United States Patent and Trademark Office

APPLICATION NO.	FI	LING DATE	FIRST NAMED INVENTOR	ATTORNEY DOCKET NO.	CONFIRMATION NO.	
10/622,894	10/622,894 07/18/2003		Hardayal Singh Gill	HIT1P029/HSJ9-2003-0109US	HIT1P029/HSJ9-2003-0109US 5016	
50535	7590	05/19/2005		EXAMINER		
ZILKA-KOTAB, PC				HEINZ, ALLEN J		
P.O. BOX 721120 SAN JOSE, CA 95172-1120				ART UNIT	PAPER NUMBER	
•				2653

Application No.	Applicant(s)					
Office Astical Commence	10/622,894	GILL, HARDAYAL SINGH					
Office Action Summary	Examiner	Art Unit					
	A. J. HEINZ	2653					
The MAILING DATE of this communication app Period for Reply	ears on the cover sheet with the c	orrespondence address					
A SHORTENED STATUTORY PERIOD FOR REPLY THE MAILING DATE OF THIS COMMUNICATION. - Extensions of time may be available under the provisions of 37 CFR 1.13 after SIX (6) MONTHS from the mailing date of this communication. - If the period for reply specified above is less than thirty (30) days, a reply if NO period for reply is specified above, the maximum statutory period was a reply reply received by the Office later than three months after the mailing earned patent term adjustment. See 37 CFR 1.704(b).	i6(a). In no event

Fig. 12

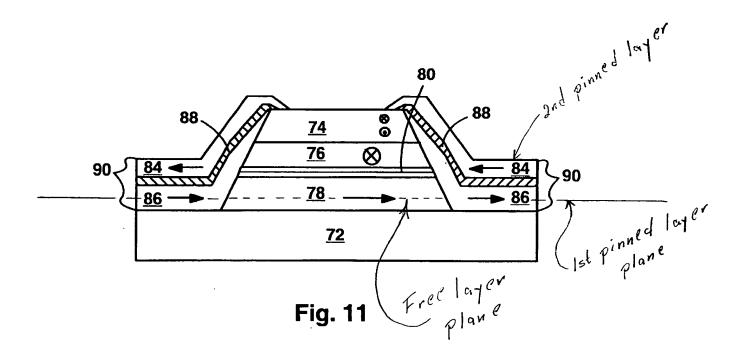
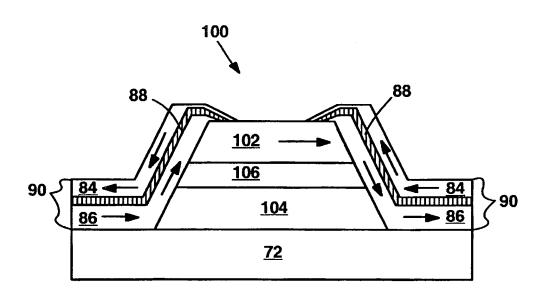
- (e) the invention was described in (1) an application for patent, published under section 122(b), by another filed in the United States before the invention by the applicant for patent or (2) a patent granted on an application for patent by another filed in the United States before the invention by the applicant for patent, except that an international application filed under the treaty defined in section 351(a) shall have the effects for purposes of this subsection of an application filed in the United States only if the international application designated the United States and was published under Article 21(2) of such treaty in the English language.
- 4. Claims 13,15,18&20 are rejected under 35 U.S.C. §102(b) as being anticipated by Carey.

See Fig. 11. Note, to the extent claimed and understood, the structure as shown in Addendum A reads on and performs to the same degree as claimed.
